MEMORANDUM

To: Harbor Springs Planning Commission
Date: March 16, 2026
From: Lynée Wells, AICP
RE: Height in Residential

5.0 Building Height with Variable Grade

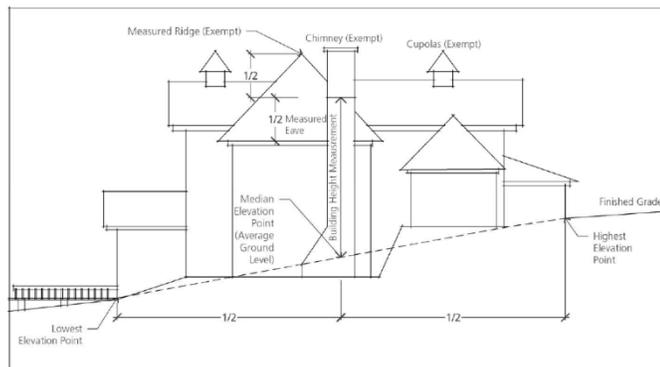
The Article 14 definition of building height states that height is measured to the highest measurable point on a building. However, the Article 15 diagram “Building Height with Variable Grade” (Section 5.0) depicts height as measured to the midpoint of the roof — the “1/2 Measured Eave” point — not to the ridge. These are two fundamentally different measurements. On a steep-pitched roof, the difference between the eave midpoint and the ridge can easily be 5 to 8 feet or more.

The Grade definition defers to the Article 15 diagram, which uses a median elevation point between the lowest and highest elevation points of the building footprint — a building-centered measurement. Grade, Mean is measured at the parcel boundary lines. These two definitions produce different base elevations and are not reconciled anywhere in the ordinance. It is unclear which governs for height measurement purposes, and the Building Height definition does not specify.

The most significant problem is that anchoring grade measurement to the building footprint — rather than to fixed lot lines or elevation at the street — allows a developer to manipulate the effective height limit through siting and grading decisions. On a sloped lot, an applicant can:

- Site the building as high on the lot as setbacks permit, reducing the apparent grade differential captured in the building-wall measurement
- Excavate or regrade the downhill side of the footprint to bring the lowest elevation point up, thereby raising the median elevation point used as the base
- Use a narrow building footprint oriented perpendicular to the slope to minimize the grade differential between the lowest and highest elevation points

All of these are legal moves under the current framework that effectively add height — as experienced from the street, from neighboring properties, and from the water — without technically exceeding the numerical limit. In Harbor Springs, where bluff lots and sloped residential properties are common, this is not a hypothetical vulnerability. It is a predictable consequence of a grade measurement that floats with wherever the applicant chooses to place the building.

The corrective is to anchor the height measurement to fixed reference points that the applicant cannot control: the existing grade at the parcel boundary lines, or the established grade at the street right-of-way. This is consistent with the Grade, Mean definition already in the ordinance — which measures at the boundary lines of the site — and with standard practice in communities managing variable topography.

BUILDING HEIGHT, FEET (Proposed): *The vertical distance measured from the mean grade to the highest point of the roof. Mean grade shall be calculated in accordance with the definition of Grade, Mean in this Ordinance, using elevation points measured at the parcel boundary lines uniformly spaced and not more than one hundred (100) feet apart. For buildings on through lots or corner lots with frontage on more than one street, building height shall also be*

calculated independently at each street frontage using the established grade at the right-of-way line, and the height as measured from any street frontage shall not exceed the maximum permitted height.

This proposed language does three things: it resolves the contradiction between the definition and the diagram by specifying the midpoint-to-ridge method for pitched roofs; it ties grade measurement to the parcel boundary lines using the Grade, Mean definition already in the ordinance; and it adds independent frontage measurement for through and corner lots to ensure the height limit is meaningful from every public vantage point — including the downhill street face on Harbor Springs’ bluff properties.

3.0 Basic Floor Terms

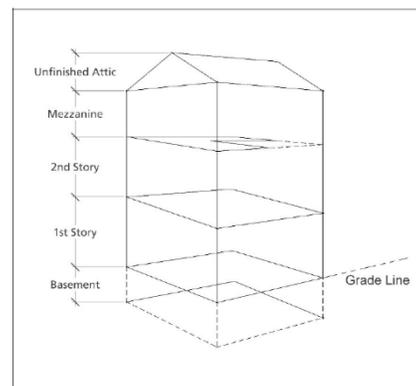
Article 15 of the new ordinance includes a graphic illustration of “Basic Floor Terms” (Section 3.0) that depicts a building stack of: Basement → 1st Story → 2nd Story → Mezzanine → Unfinished Attic. Under a 3-story maximum, this illustration endorses a structure with three full stories plus a mezzanine plus an unfinished attic — potentially five distinct functional levels — with no story count violation. (Pages 161-162)

The unfinished attic category creates a compounding enforcement problem. An attic space that is unfinished at the time of permit issuance can be finished through a simple interior renovation after a certificate of occupancy is issued. Michigan’s building code regulates structural modifications, electrical, mechanical, and plumbing work — but it does not exist to enforce zoning story limits. Once a certificate of occupancy is granted for a structure with an “unfinished attic,” there is no reliable mechanism within the zoning framework to prevent that space from becoming a full habitable floor over time, and no practical way for the Zoning Administrator to monitor conditions after the fact.

Additionally, the term “mezzanine” appears in the Article 15 illustration but is not defined anywhere in Article 14. There is no language telling the Zoning Administrator whether a mezzanine counts toward the story maximum or how it interacts with the 3-story limit. This is an independent gap that compounds the attic problem.

- Add a definition of “mezzanine” to Article 14, clarifying whether it counts toward the story maximum
- Define the conditions that make an attic space a story regardless of finish level, including structural floor, stair access, and ceiling height thresholds
- Require that conversion of attic space to habitable use trigger a new zoning determination, regardless of whether exterior modifications are proposed
- Consider adding a condition of approval to residential permits that attic space may not be converted to habitable use without a new zoning permit confirming continued compliance with story limits
